SI M51 12 16
Body

SERVICE ACTION: RUBBER STRIP ON REAR SIDE WINDOW TRIM IS CRACKED

F54 (Cooper S Clubman)

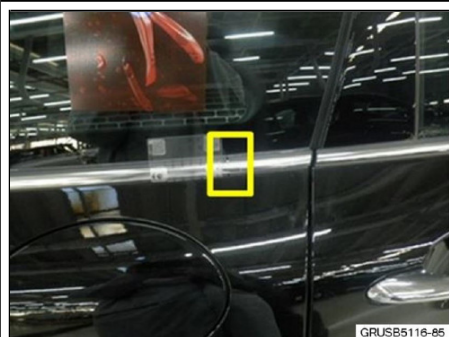
The rubber strip on the rear side window trim may crack. In some cases a gap may be evident on the rubber trim strip.

Results are cosmetic- no water leakage or sound intrusion.

Inspect and replace, if any crack is evident. Make sure part is index 08, or higher.

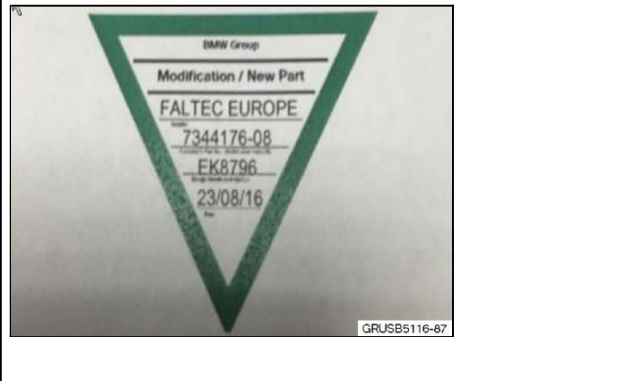
1. Check the rubber strip on the trim below the fixed rear window. **Is the rubber strip cracked?** YES- replace the trim strip following **REP 51 36 040** "Removing and installing/replacing strip on rear left or right side window". NO- Go to next step 2.

Note: the rubber strip is part of the trim.
